Tech Tip

Blue Bird Type C & D w/Air Ride – Exhaust Shield

Figure #1

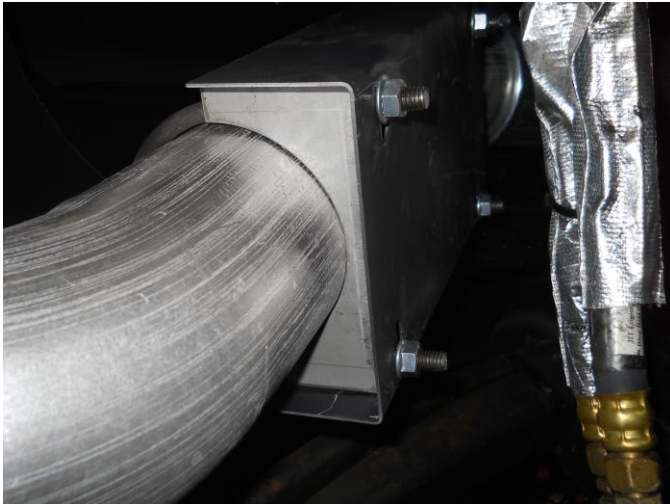
- Complaint –** There is an air leak at the back of the unit
- Cause –** New York Bus Sales as an added protection to the rear air brake lines added an exhaust shield (Figure #1). The bracket will over time cut into the air brake hose causing a leak.
- Correction –** Remove the shield – The foil wrap installed by Blue Bird is more than sufficient protection for the hoses.
